SERVICE BULLETIN

DATE: 12 SEPTEMBER 1977

INSPECTION OF PN 369A3511 – 15 AND 369A3511 – 17 TAILBOOM BRACKET ASSEMBLIES, TAIL ROTOR TRANSMISSION ATTACHMENT

Figure 1. Rework of Tailboom - Replacement of 369A3511-15 and 369A3511-17 Brackets.

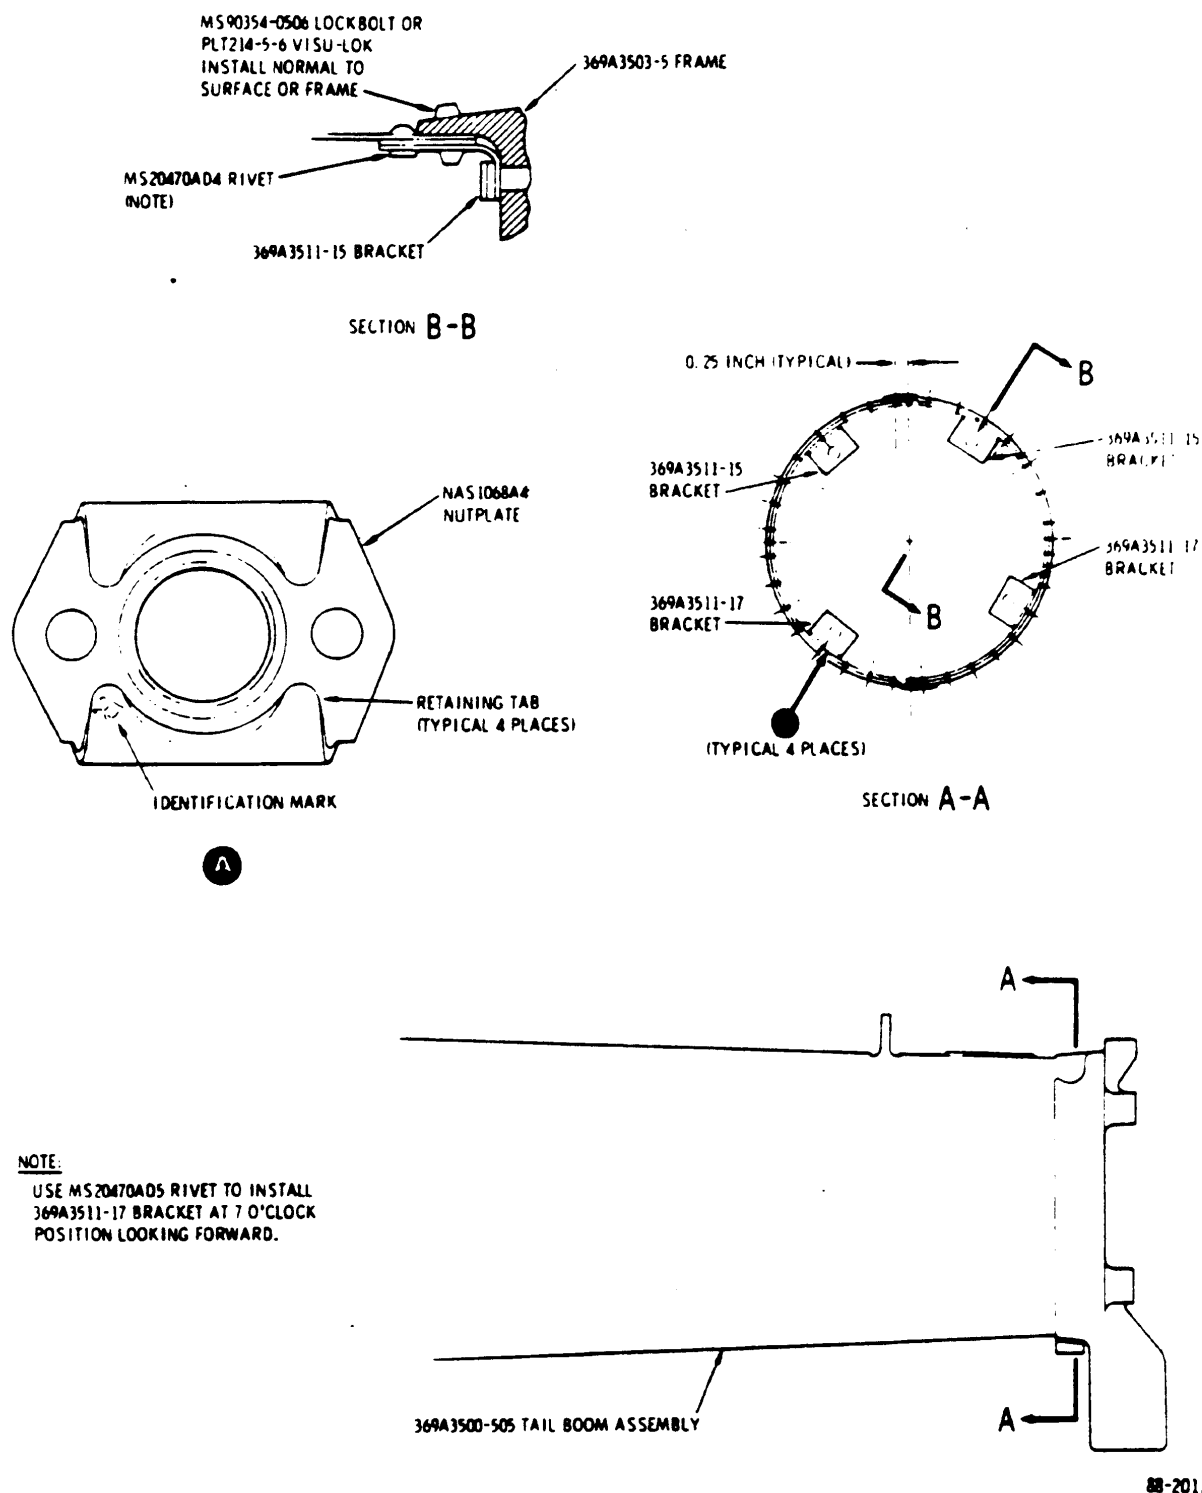
The information given in this Service Information Notice lists a procedure for field inspection and replacement, as required, of the subject brackets installed on the aft end of the tailboom. Field reports indicate that cracks have occurred in the anchor nut incorporated in the bracket assembly, resulting in loss of torque on the tail rotor transmission attach bolt.

- (2). Using dental mirror and high intensity light, inspect each of the four tail-boom brackets for an identification mark "R" impression stamped on one of the NAS1068A4 nut plate retaining tabs. Check all tabs on each nut plate. (See Figure 1.)

1. If an identification mark "R" is noted on nutplate of any tailboom bracket, replace bracket as follows:

- (a) Locate and identify existing lockbolt and rivet securing B69A3511-15 or 369A3511-17 bracket to tailboom. (See Figure 1.)

NOTE: MS90354-0506 lockbolts (or Visu- Loks PLT21 4- 5-6) are used to install brackets to 369A3503-5 tailboom frame and 369A3500-23 doublet. An MS20470AD5 rivet is used to install the 369A3511-17 bracket to the -?-3 doublet at the 7 o' clock position, looking forward. MS20470AD4 rivets are used at the other three bracket locations.

- (b) Remove existing lockbolts and rivets securing the tailboom bracket; remove and discard bracket.

- (c) Mate replacement bracket with existing holes in frame and doublet, and install with lockbolts (or Visu-Loks) and rivets as shown with zinc chromate primer.

- (d) For Visu-Lok installation only, predrill holes with #25 drill and ream holes to 0.164/0.163 inch diameter. Torque check (CCW) to 4 inch-pounds maximum; do not over torque.
